TOLEDO - LUCAS COUNTY PLAN COMMISSIONS

DATE: August 13, 2021

REF: SUP-5002-21

SUBJECT: Special Use Permit for a gas station with convenience store

Revised Site Plan

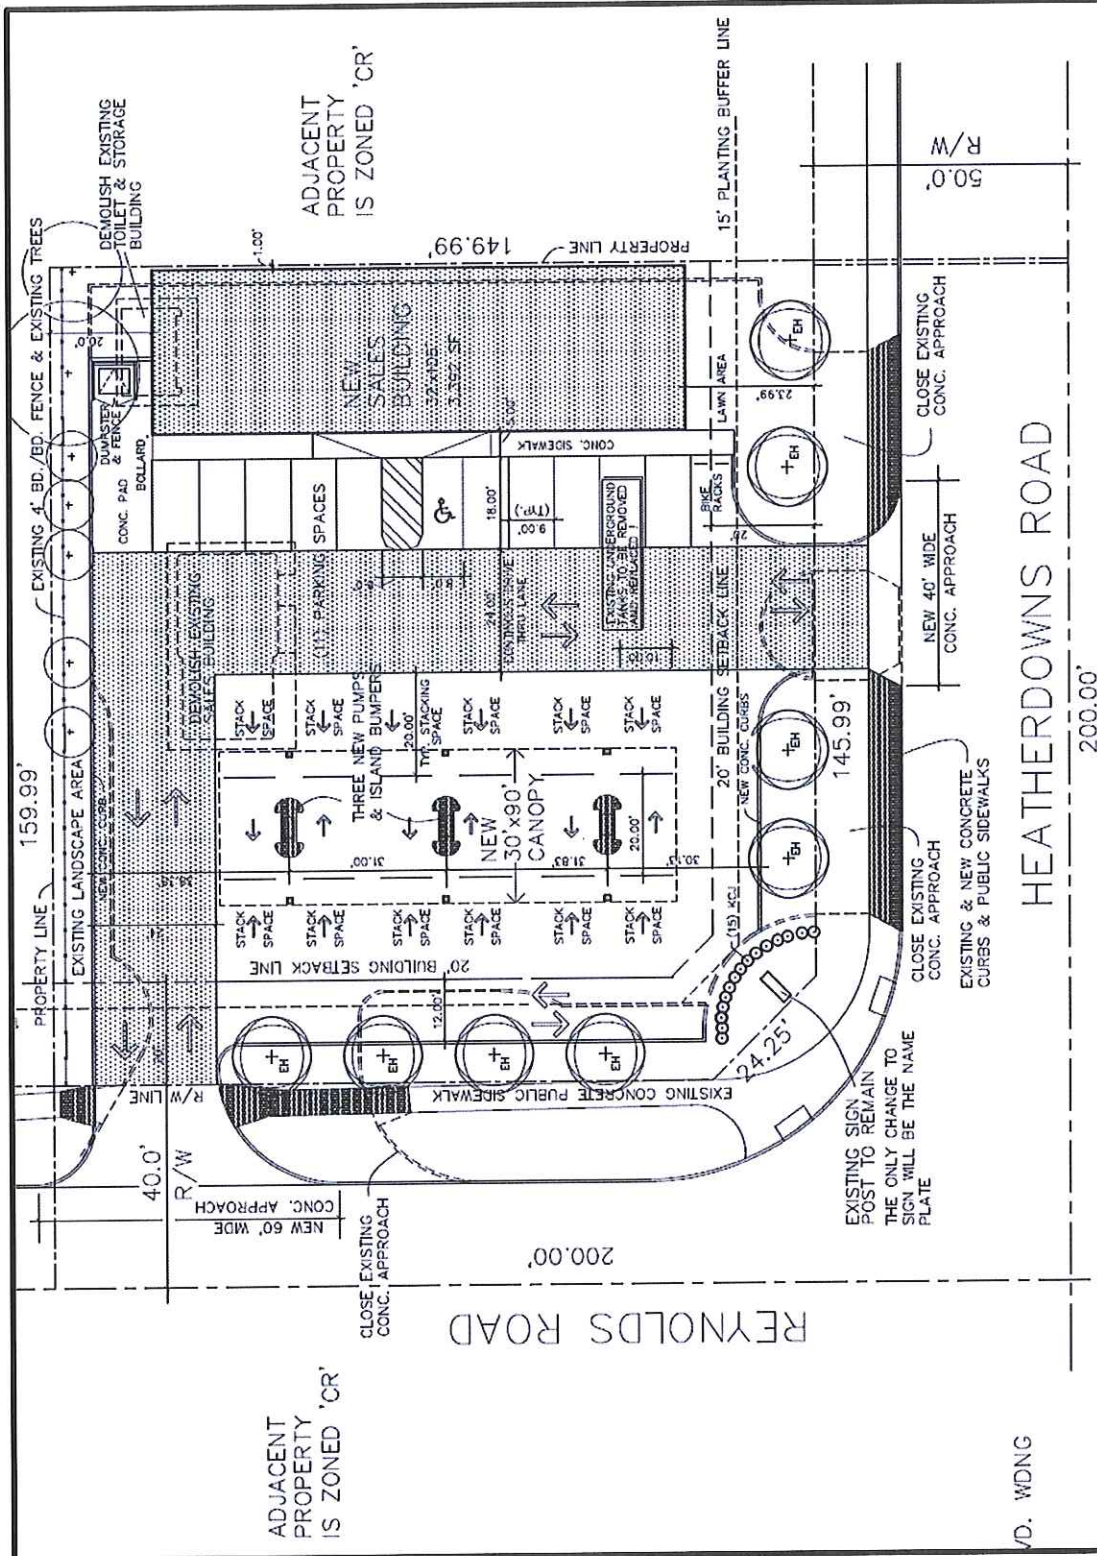
Staff identified that required stacking is indicated on the revised site plan. Per **TMC§1107.1601 - Minimum Number of Spaces**: One (1) stacking space, at least ten-feet (10') by twenty-feet (20') wide is required per pump island. Per **TMC§1107.1911 – Dimensions**: a twenty-five-foot (25') drive aisle is required. This is indicated in the revised site plan.

Per **TMC§1108.0202**, the frontage greenbelt shall contain one (1) tree for every thirty (30) feet of frontage. A strict enforcement of TMC§1108.0202 would require five (5) trees on the S Reynolds Road frontage, and five (5) trees on the Heatherdowns Road frontage. The site plan indicates four (4) new trees on S Reynolds Road, and four (4) new trees added to Heatherdowns Blvd frontages. This is a new building so the revised site plan does not meet these requirements and this is listed as a condition.

Per **TMC§1108.0204 Parking Lot Landscaping** applies to all off-street parking lots containing five or more off-street parking spaces for any use. The total interior landscaping required in parking lots is 20 square feet per parking and stacking space. Based on the indicated parking spaces abutting the convenience store, the parking at six (6) pumps, and stacking, there should be 460 square feet of landscaping and is listed as a condition.

Perimeter parking lot landscaping applies to access drives, driveways, aisles, and loading areas, and shall be provided around the entire perimeter of the site. Due to siting the building on the eastern property line, as presented, the perimeter landscaping is not compliant.

32. Designated pedestrian crossings at least 5 feet wide must be provided to ensure pedestrian safety. Per **TMC§1107.1602.B** pedestrian walkways that cross vehicle stacking lanes must be clearly marked through the use of durable, low maintenance surface materials such as pavers, bricks, scored concrete or scored and painted asphalt: **not acceptable as depicted on site plan.**

34. Dumpster location(s) shall be clearly defined, have a concrete pad and be surrounded by a solid wooden fence or a masonry screen enclosure with landscaping and shall not be located in any required setbacks or the public right-of-way as stated in **TMC§1361.10(b) (10)** of the Building Code; **location and pad are acceptable as depicted on revised site plan. However, enclosure materials and landscaping must be indicated.**

38. Per TMC 1103.0708 One high profile sign may be installed as an alternative and substitute fascia or wall sign for business establishments. A high-profile sign shall not exceed twelve (12) feet in height above the grade elevation of the nearest right-of-way; **not acceptable as presented. The existing sign post must be brought into compliance.**

- a. A fifteen-foot (15') greenbelt is required along S Reynolds Road and Heatherdowns Blvd frontages and shall include one (1) tree for every thirty (30') of lot frontage; **not acceptable as depicted.**

- b. Interior parking lot landscaping required in parking lots is 20 square feet per parking and stacking space. Based on the indicated parking spaces abutting the convenience store, the parking at six (6) pumps, and stacking, there should be 460 square feet of landscaping; **not acceptable as depicted.**

- c. The following shall be provided for interior site landscaping: one (1) two-inch (2") caliper tree for every 1000 square feet of building coverage (footprint); foundation plantings along all portions of the building that are visible from the public rights-of-way and at all major building entrances. Landscape plan depicts no 2" caliper trees or foundation plantings needed to meet interior site landscaping requirements; **not acceptable as depicted.**

- d. Perimeter landscaping must consist of a landscape area at least 10 feet in width, exclusive of sidewalks, walkways, trails, or right-of-way and must be located between the parking lot and the property line; **not acceptable as depicted on revised plan.**
